EPA COMMENTS

**DRAFT LOWER PASSAIC RIVER STUDY AREA REMEDIAL INVESTIGATION/
FEASIBILITY STUDY
REMEDIAL INVESTIGATION REPORT – SECTION 7 AND MODELING APPENDICES
DATED APRIL 2015 AND JUNE 2015**

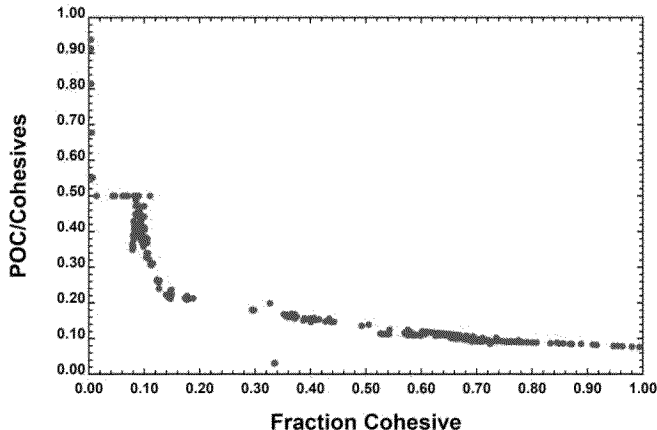
515	Section F.4, page 7, last paragraph	Figure 25 is a good summary figure showing an upstream decrease in median settling velocity. However, the explanations for this trend presented at the bottom of page 7, while plausible, are not the only possible explanations and are not clearly related to most of the previous discussion. Please revise the text and provide additional figures to more explicitly demonstrate the connections between these potential explanations for the upstream decrease in settling velocity and the previously described behaviors. This might include, for example, a graph depicting an upstream decrease in tidal velocity that accompanies the observed upstream decrease in median settling velocity.
516	Section F.4, page 8	The parameterization of the observed behavior as the sum of the behaviors of two independent particle classes of different origin and different settling velocities is abruptly proposed at the end of Section F.4. While this may be a reasonable way to parameterize sediment settling behavior in the LPR, it is not necessarily the only possible explanation and its relationship to the preceding analysis needs to be more explicitly described. Please revise the text to clarify how this parameterization helps to explain the previous observations of relationships between water velocity and settling velocity at different locations; how these two particle classes will be implemented and what their characteristic settling velocities are; whether there will be any exchange between the two classes; and how this parameterization compares to the previously presented data.

**Figure 1 using revised
Corbicula weights**

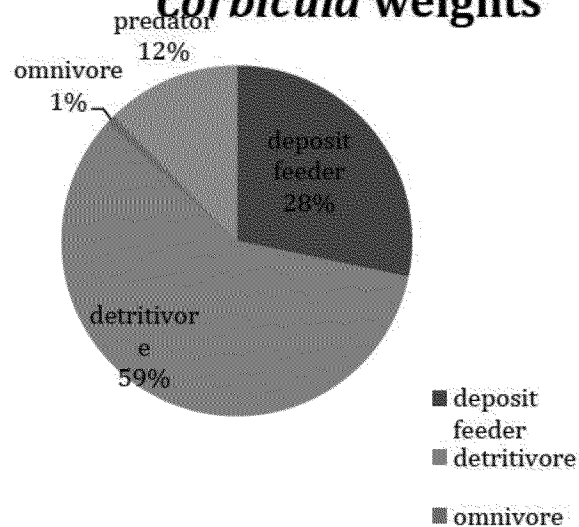
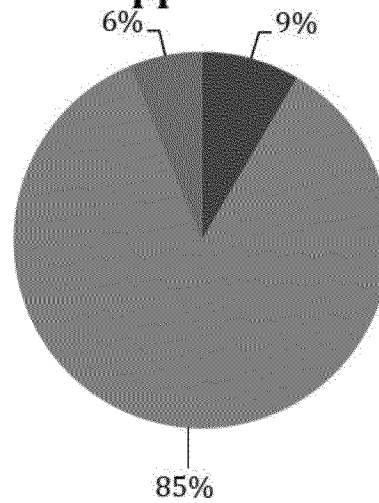
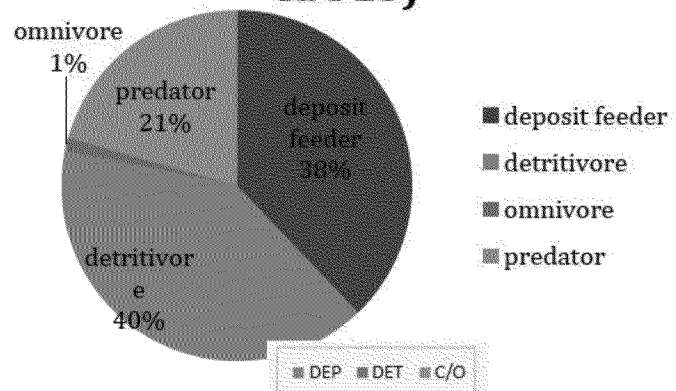
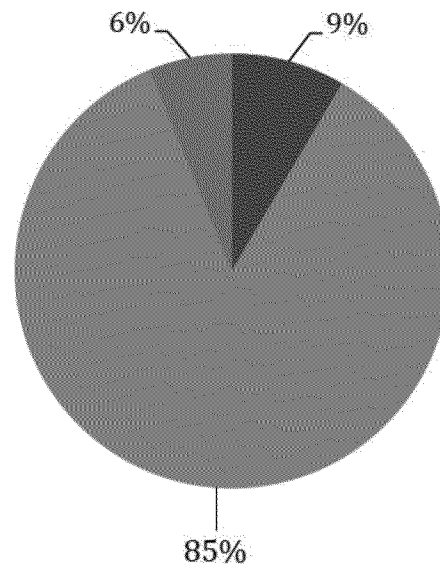
In February of 2015, in a discussion of benthic feeding zones, the CPG presented images and specimens to EPA that suggest that typical clams in the LPRSA are tiny, with a maximum shell width of approximately 5 millimeters (mm), as shown below.

Using this picture and generic weight-to-shell-width data (Helm et al. 2004), the mean biomass of a 4-mm bivalve can be estimated as 17 milligrams (mg), which is over 3 times less biomass than estimated by the CPG using the Chesapeake Bay data. Substituting this alternate wet weight for *Corbicula* into Figure 1 results in the figure shown below.

If the same pie chart were derived using abundance data for RM 4 to RM 13, it suggests that deposit feeders make up 38% of the benthic biomass and detritivores only 40%.

Changing the RM basis in this manner demonstrates how much the benthic makeup can vary spatially, and that the assumption of a study area-wide detritivore-dominated bed is not supported.

<p>Finally, as illustrated in the taxa-specific pie chart above, the data used to derive Figure 1 of Appendix E suggest that the Asian clam dominates the detritivore category in terms of biomass. However, based on an examination of the literature used to convert ash-free dry weight (AFDW) to wet weight (Ricciardi and Bourget 1998), the wet weight biomass includes the shells of these clams¹, which should not be considered a viable part of prey biomass. This undoubtedly also inflates the weights of <i>Corbicula</i> relative to other portions of the food web.</p> <p>Ultimately, each of these lines of evidence suggests that the CPG is significantly overstating the quantity of detritivores in the LPR and their role as prey items in the food web. The CPG must discard the flawed analysis that was used to define the proportion of benthic biomass across the LPRSA and a new analysis must be performed. As part of this new analysis, <u>shell-free</u> <i>Corbicula</i> wet weights must be estimated. If non-site-specific biomass data are used, sampling from more than one external site must be included. The CPG must also consider differences in benthic makeup by RM and derive a detritivore-to-deposit-feeder ratio for each salinity zone included in the BERA. Feeding preferences must be modified based on this new analysis (refer to Comment Nos. 615 through 617). Finally, if study area-specific biomass or wet weight data are unavailable, the uncertainty in the benthic invertebrate composition must be thoroughly assessed throughout model calibration and assessment of remedial alternatives.</p>
